## T10/07-312r2 SAS-2 Zoning route table entries for subtractive ports

To: T10 Technical Committee  
From: Tim Symons, PMC-Sierra (Tim\_Symons@pmc-sierra.com)  
Date: 4 July 2007  
Subject: 07-312r2 SAS-2 Zoning route table entries for subtractive ports

Figure 56 — Zoning expander route table

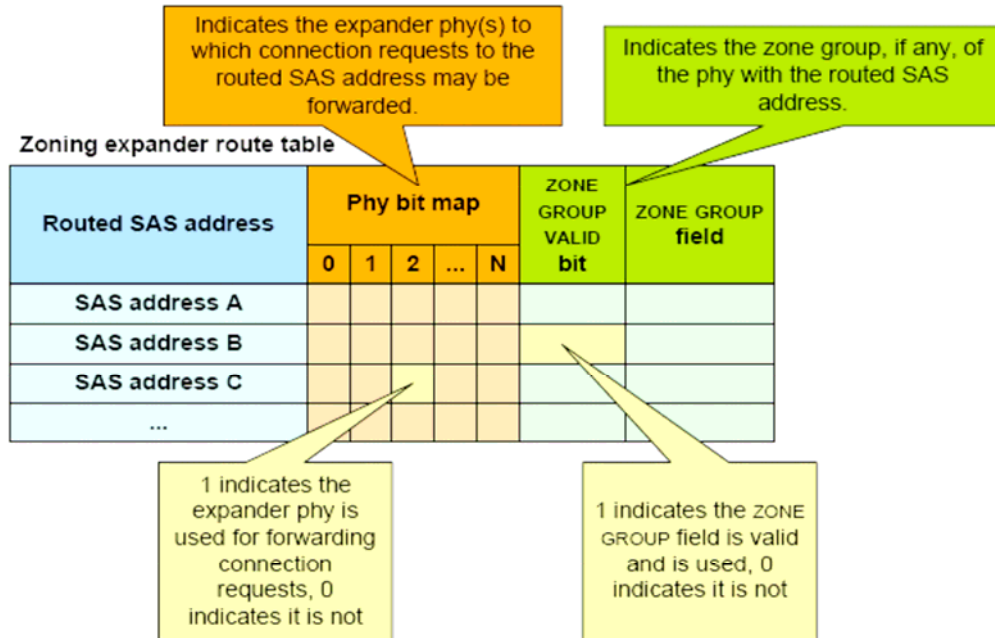
A zoning expander route table is an expander-based expander route table (see 4.6.7.3) that is able to hold the zone group of ~~each~~ routed SAS addresses.

Figure 56 shows a representation of the zoning expander route table.

The zoning expander route table:

- a) shall include discovered SAS addresses for all phys with the ROUTING ATTRIBUTE field set to 2h (i.e., table); and
- b) may include discovered SAS addresses for all phys with the ROUTING ATTRIBUTE field set to 1h (i.e., subtractive).

The total number of routed SAS addresses shall not exceed the value indicated in the MAXIMUM NUMBER OF ROUTED SAS ADDRESSES field.

The zone route table may include SAS addresses for phys with the ROUTING ATTRIBUTE field set to 1h (i.e., subtractive) until the total number of routed SAS addresses in the zone route table is equal to the value indicated in the MAXIMUM NUMBER OF ROUTED SAS ADDRESSES field. The method of selection is vendor specific.
